| Title Pre/Main | | | |
| Size A4 | Number BN2009003 | | Revision 1.1 |

| Title | | | Mother Board of MCS130 | | |

| Title Pre\Main\Buffer_WI | | | |

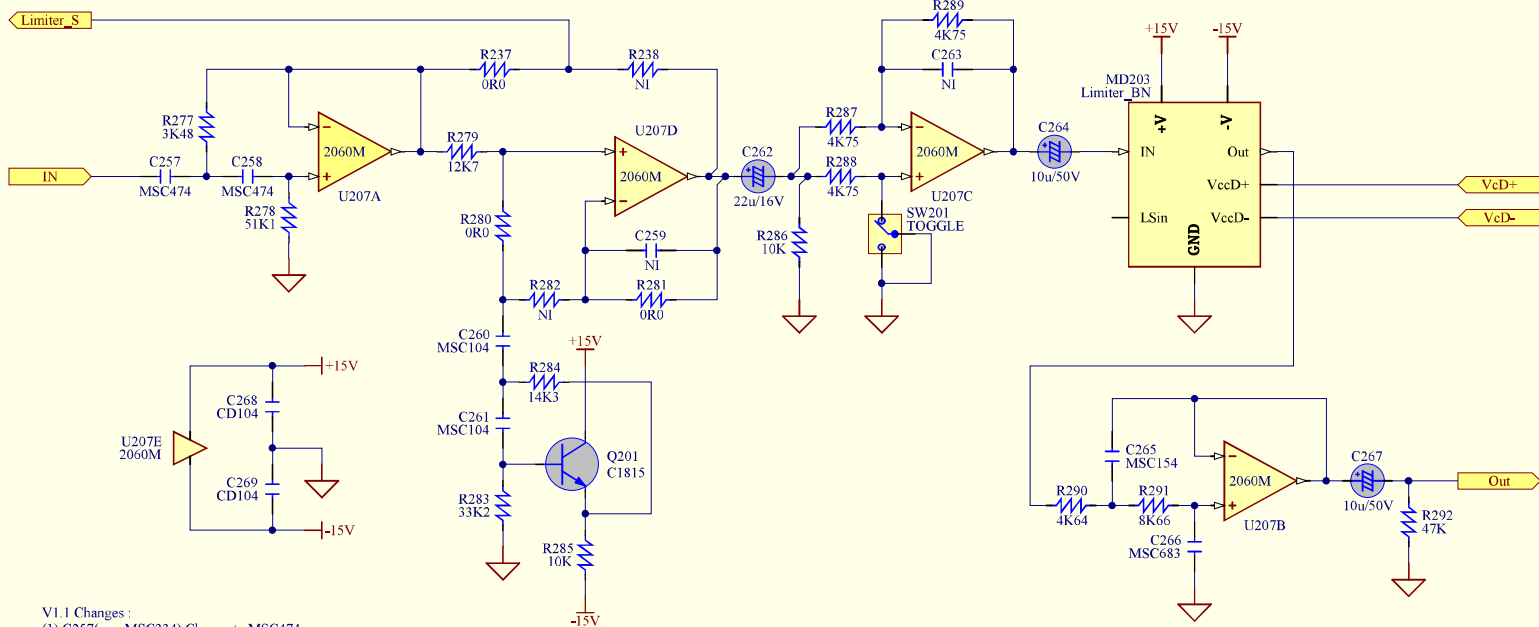
V1.1 Changes :
 (1) C257(was MSC334) Change to MSC474
 (2) C258(was MSC334) Change to MSC474
 (3) C260(was MSC154) Change to MSC104
 (4) C261(was MSC154) Change to MSC104
 (5) R277(was 3K92) Change to 3K48
 (6) R278(was 76K8) Change to 51K1
 (7) R279(was 6K65) Change to 12K7
 (8) R283(was 33K2) Change to 33K2
 (9) R284(was 11K0) Change to 14K3

| Title Pre\Main\SUM_LFE | | | |

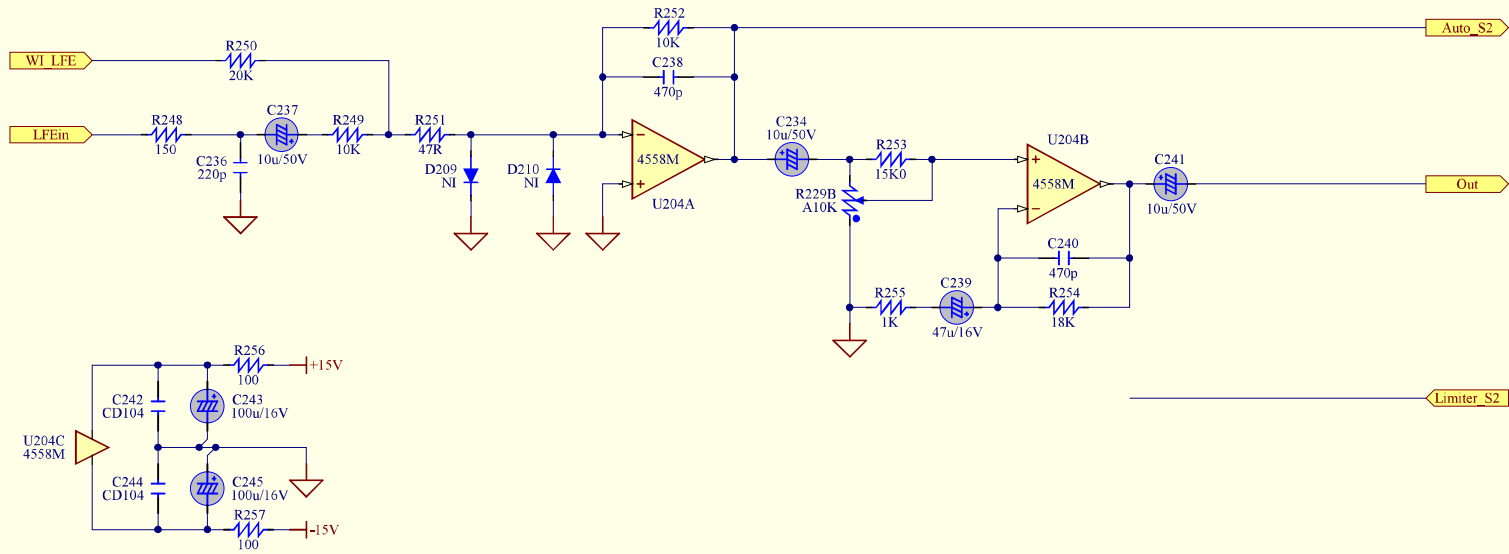
V1.0 Changes :
(1) Cancel MD202
